**A30 Chiverton to Carland Cross  
TR010026**

**8.25 COMMENTS ON INTERESTED  
PARTY SUBMISSIONS AT DEADLINE 5**

## 2.3 Hearing Action Point 4: Comments on Mr Tofts' (on behalf of Mr Parker) response to Hearing Action Point 2

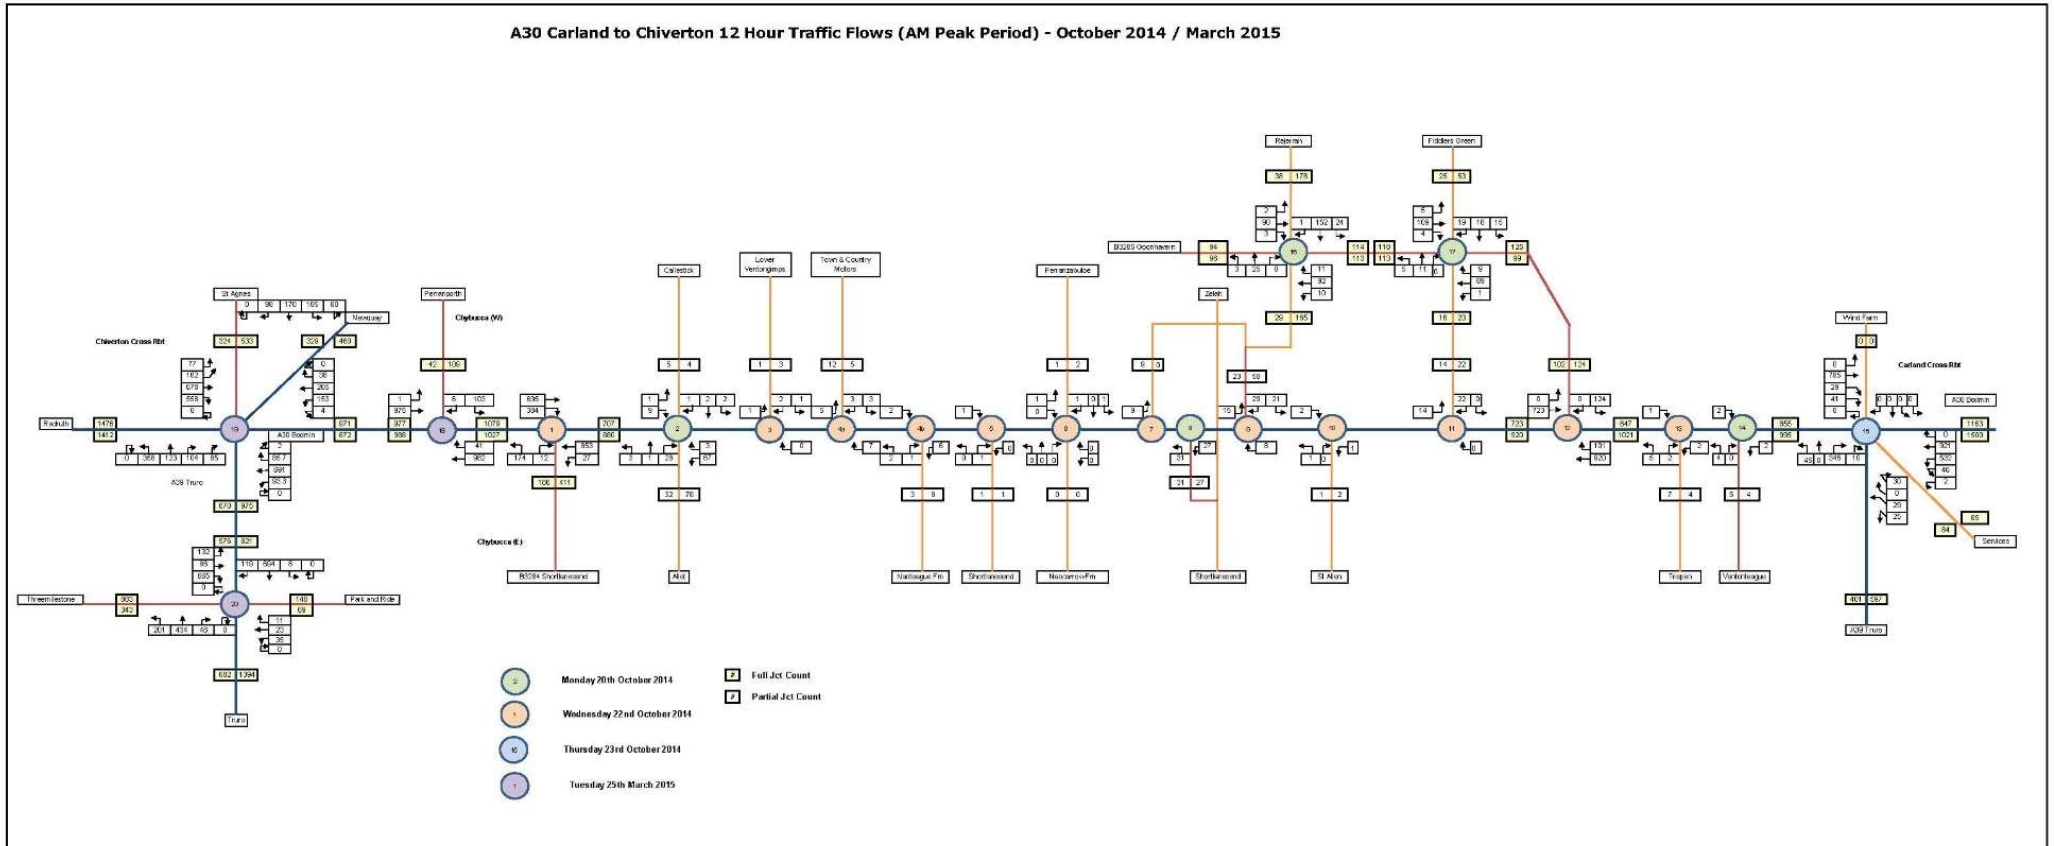
- 2.3.25 In response to paragraph 4.11, reviewing the left turning traffic at Chybucca (W) from the B3284 "Perranporth" southeast bound to the A30 eastbound, the figure quoted should be 54 movements (as shown in the updated traffic flow diagram in Appendix A of this response) compared to the 326 movements quoted in Annex A of the PCF Stage 3 Traffic Data Collection Report [REP5-030]. The 54

movements compare to 56 movements observed as stated in the PCF Stage 3 Local Model Validation Report [REP5-028]. The slight difference between the observed figure in the PCF Stage 3 Local Model Validation Report [REP5-028] and the revised traffic flow diagram is due to factoring to allow conversion of the flows to passenger car units (pcus). The same modelled turning movement in the A30 base year traffic model is 108 movements which is within the threshold required by the WebTAG model validation criteria for this turning movement, demonstrating that the model validates at this location.

- 2.3.26 The updated observed traffic movement diagram for the PM peak (as shown in Appendix A) addresses the issues raised in Paragraphs 4.11 – 4.16 of the CCL Technical Note.

A30 Carland to Chiverton 12 Hour Traffic Flows (AM Peak Period) - October 2014 / March 2015

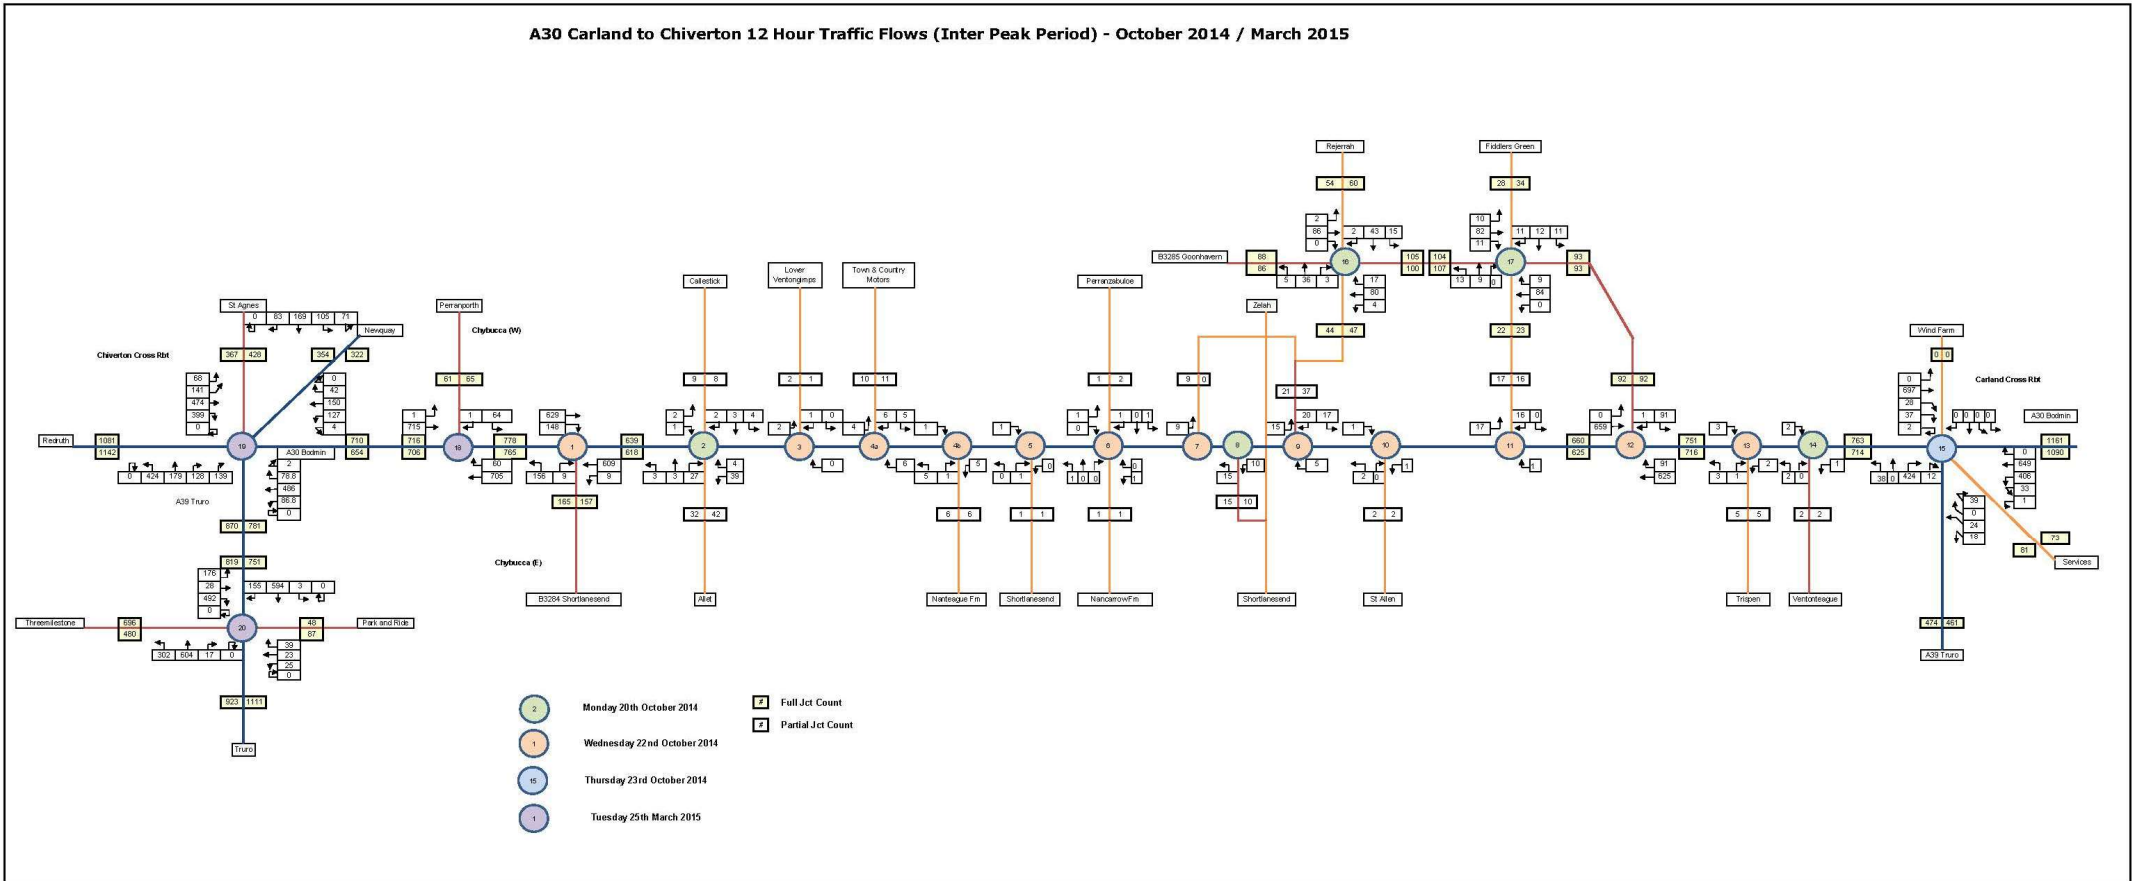
- 2.3.20 In response to the point raised in Paragraph 4.3 of the CCL Technical Note, the right turning traffic at Chybucca (W) from the A30 westbound to the B3284 "Perranporth" northwest bound the figure quoted should be 41 movements (as shown in the updated traffic flow diagram in Appendix A of this document) instead of the 384 movements quoted in Annex A of the PCF Stage 3 Traffic Data Collection Report [REP5-030].

- 2.3.21 The 41 movements compare to 39 movements observed as stated in the PCF Stage 3 Local Model Validation Report [REP5-028]. The slight difference between the observed figure in the LMVR and the revised traffic flow diagram in Appendix A is due to factoring to allow conversion of the flows to passenger car units (pcus). The modelled turning movement for this movement across the junction in the A30 base year traffic model is 96 movements. The difference between the observed and modelled flow is within the threshold (being individual flows within 100 vehicles per hour (veh/hr) of the observed flow) which is required by the WebTAG model validation criteria for this turning movement, demonstrating that the model validates at this location.

- 2.3.22 The updated observed traffic movement diagram for the AM peak (as shown in Appendix A of this document) addresses the issues raised in Paragraphs 4.3 – 4.7 of the CCL Technical Note.
